NEPA/CEQA RE-VALIDATION FORM (rev. 03/2024)

***Stockton Channel Viaduct Rehabilitation Project
CEQA Addendum/NEPA Re-Validation December 2025***

**10-0X460, 10-0X461, and 10-0X462
Stockton Channel Viaduct Rehabilitation Project
CEQA Addendum/NEPA Revalidation
State Clearinghouse Number 2017072033**

**Interstate Highway 5 in San Joaquin County
SJ-05 PM 25.6-28.0
SR-04 15.7-16.2**

Figure 3: Construction Staging Plan

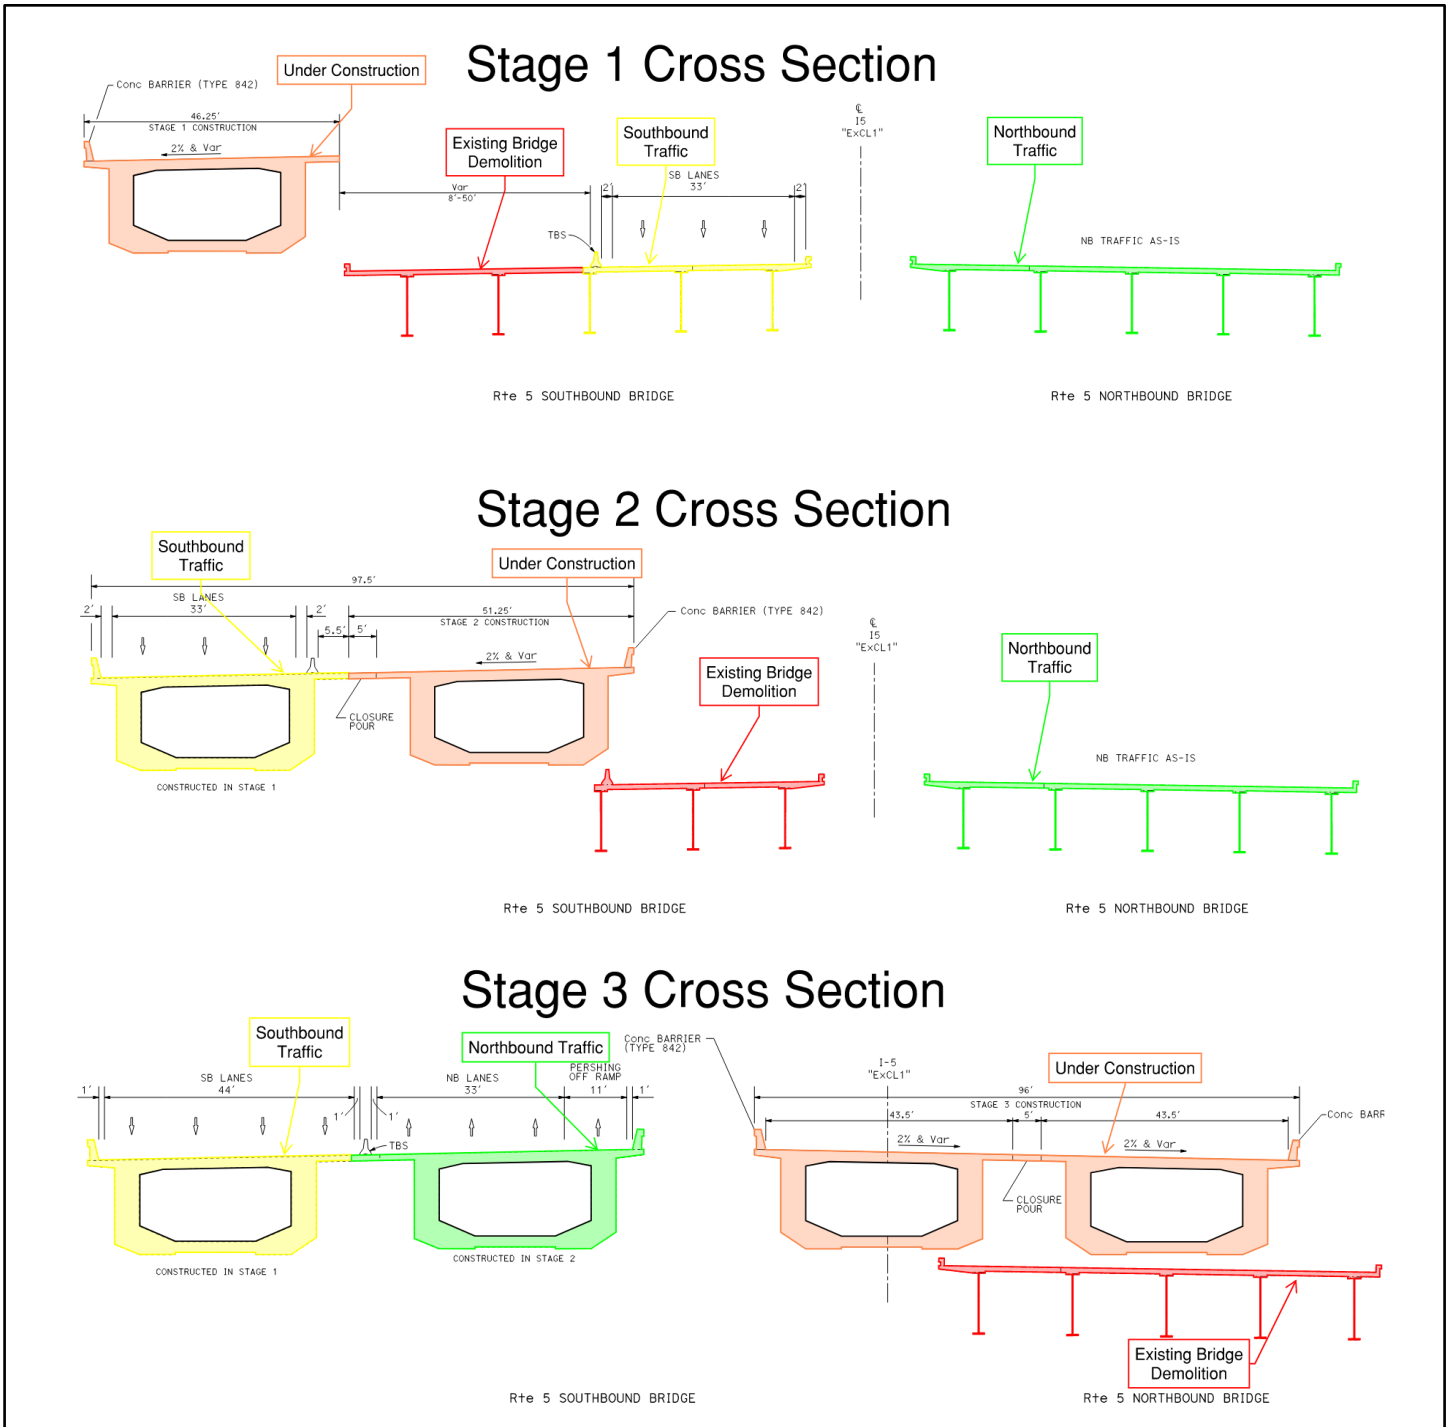
The project was previously planned to be built in four stages. Caltrans has decided to close one lane of traffic in each direction in certain stages of the project, and it will now be built in three stages.

Stage 1 (Southbound Exterior): During Stage 1, the exterior half of the existing southbound bridge will be demolished. This includes the bridge deck, steel girders, concrete columns, and partial footing demolition as required for installation of new cast-in-drilled-hole piles. This stage will include the temporary closures of the Fremont Street onramp and off-ramp, as well as the Navy Drive off-ramp. After the demolition described above, the exterior half (west) of the new southbound structure will be constructed including new in-water foundations, and reconstruction of the Fremont Street on and off-ramps, as well as the Navy Drive off-ramp.

Stage 2 (Southbound Interior): During Stage 2 construction, the remaining portion (east) of the existing southbound Viaduct substructure and superstructure elements will be demolished, and the new southbound structure will be completed. During this stage, Southbound traffic will be carried by the new southbound structure completed in Stage 1. Traffic on the northbound structure remains unchanged in this stage.

Stage 3 (Northbound): During Stage 3 construction, the entire existing northbound Viaduct substructure and superstructure elements will be demolished, and the northbound span of the new Viaduct structure will be constructed, including elevating the profile of the adjacent roadway in the northbound section at both ends of the structure and at the Pershing Off-ramp to match the new structures. During this stage, Northbound traffic will be carried in the opposite direction on the portion of the new Southbound bridge constructed in stage 2. Temporary crossovers will be constructed to get traffic from the existing Northbound approach onto the new bridge, and then back over to the existing Northbound lanes. Southbound traffic will remain in the same configuration as noted in Stage 2.

During Stage 3 construction, a temporary Pershing Off-ramp will be constructed and northbound Interstate 5 traffic exiting to Pershing Avenue will be carried on the temporary off-ramp during the time that the existing Pershing Off-ramp structural section is demolished and replaced. The temporary Pershing Off-ramp will remain in place until construction of the new Pershing Off-ramp structural section is completed.

At the conclusion of stage 3, traffic will be returned to its normal configuration utilizing the new Pershing Avenue off-ramp. See **Figure 3** for a diagram of staging sequencing.
